**PLANNED UNIT DEVELOPMENT
STAFF REPORT****Date: July 6, 2006**

<u>DEVELOPMENT NAME</u>	Grand Self Storage, LLC (Mike Daniels, Agent)
<u>LOCATION</u>	6420 Grelot Road (North side of Grelot Road, 310' + West of Hillcrest Road) and 1234 Hillcrest Road (for shared access)
<u>SUBDIVISION NAME</u>	Crest Commercial Park, Lots 2 and 5-B (Resubdivision of Lot 5)
<u>CITY COUNCIL DISTRICT</u>	District 6
<u>PRESENT ZONING</u>	B-3, Community Business District
<u>AREA OF PROPERTY</u>	73,606 ± square feet (6420 Grelot Road) 43,293 ± square feet (1234 Hillcrest Road)
<u>CONTEMPLATED USE</u>	Planned Unit Development approval to allow multiple buildings on a single building site, and shared access between buildings sites.
<u>TIME SCHEDULE FOR DEVELOPMENT</u>	Immediately

SITE PLAN

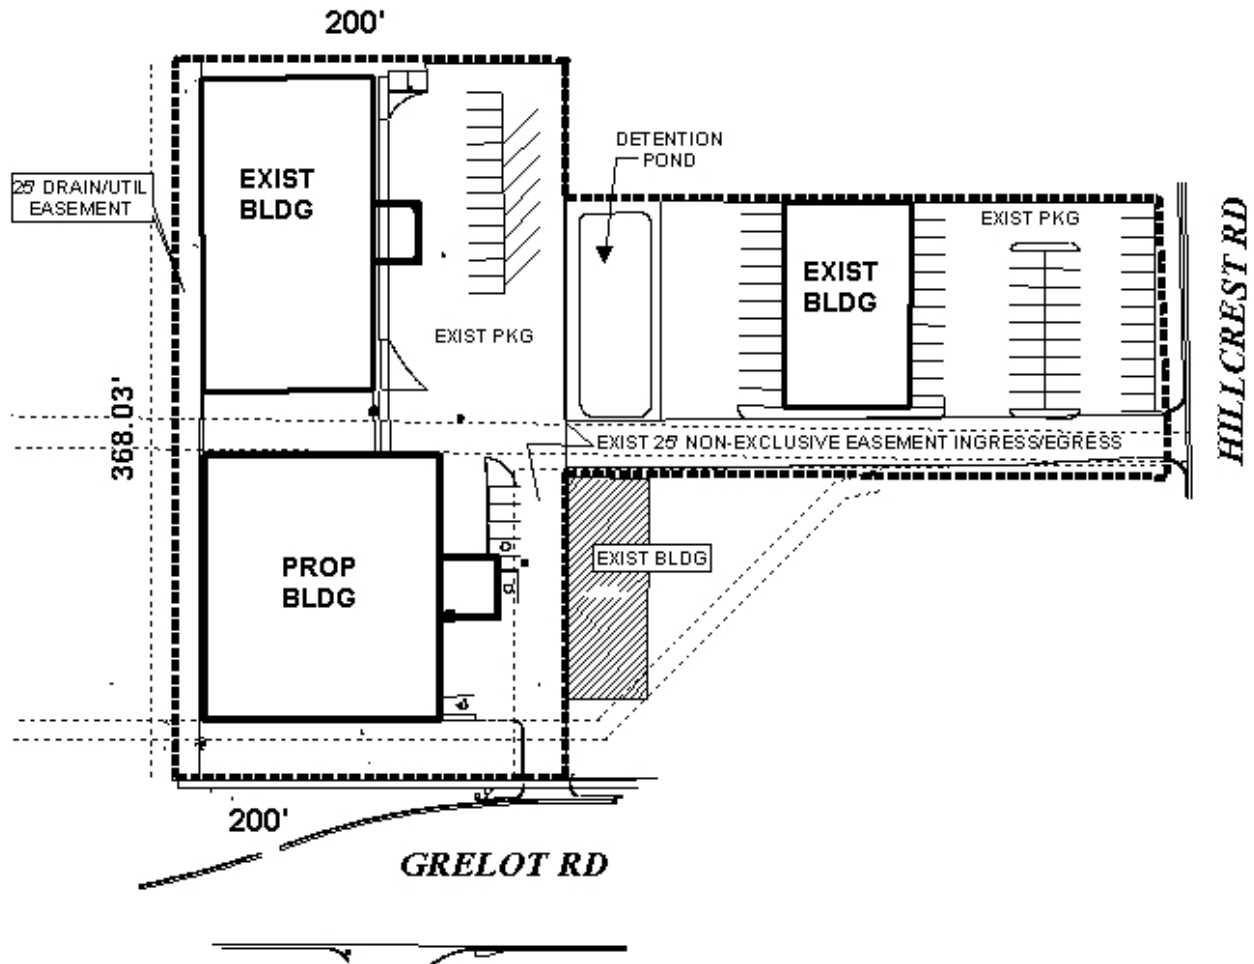
There is an existing 8'x6' stormwater drainage culvert that traverses the property parallel to Grelot Road and is located in the area shown as the proposed building. The applicant's engineer should verify the exact location of the culvert and the building should not be located over the structure or within 10 feet of the structure to allow for future maintenance.

According to construction plans for the recent Grelot Road improvements there is an existing permanent drainage easement that is not shown on the proposed drawing. The location and existence of this easement should be confirmed by the applicant's engineer.

Driveway number, size, location, and design to be approved by Traffic Engineering and conform to AASHTO standards. Minimum aisle width for angled parking is eighteen feet and for ninety-degree parking is twenty-four feet. Changes should be made to meet these requirements. Sign and mark all one-way traffic areas.

The site is located near the intersection of Grelot and Hillcrest Roads, with frontage on each street. Both Grelot and Hillcrest Roads are major streets with adequate rights-of-way. The applicant's depiction of the curbing along Grelot Road does not reflect the current condition of Grelot, namely, the fact that the roadway has been widened.

Because Grelot and Hillcrest Roads are major streets, access management is a concern. Access to Hillcrest Road should be limited to the existing curb-cut as no development is proposed for this portion of the site. Access to Grelot Road should be limited to one curb-cut, with the size, design and location to be approved by Traffic Engineering and conform to AASHTO standards.

As pointed out in the Engineering Department comments, the site where the new development is proposed is crisscrossed with stormwater, sanitary sewer, and utility easements. The applicant should verify the location of all easements, and should ensure that the proposed new construction will be adequately set back from any easements on the site.

The Traffic Engineering Department states that the parking and circulation on the site where the new development is proposed does not appear to be adequate. As the applicant proposes to develop the site with personal storage facilities, the parking required by the Zoning Ordinance would be limited to those needed to serve the on-site office, which as proposed would be 2 parking spaces. While the provision of more than two parking spaces is desirable, the parking area should be designed to meet all circulation and access requirements of the Zoning Ordinance.

RECOMMENDATION: **Planned Unit Development:** Based on the preceding, the PUD application is recommended for Holdover until the August 3, 2006 meeting, so that the applicant can provide a revised drawing to Urban Development by July 10th, addressing the following items: 1) depict all drainage and utility easements on the property, after consultation Engineering Department, and redesign of the site if necessary due to the easements; 2) redesign the parking area to meet minimum circulation and parking design requirements, per the comments provided by Traffic Engineering; and 3) depiction of the current curb-edge location for Grelot Road.
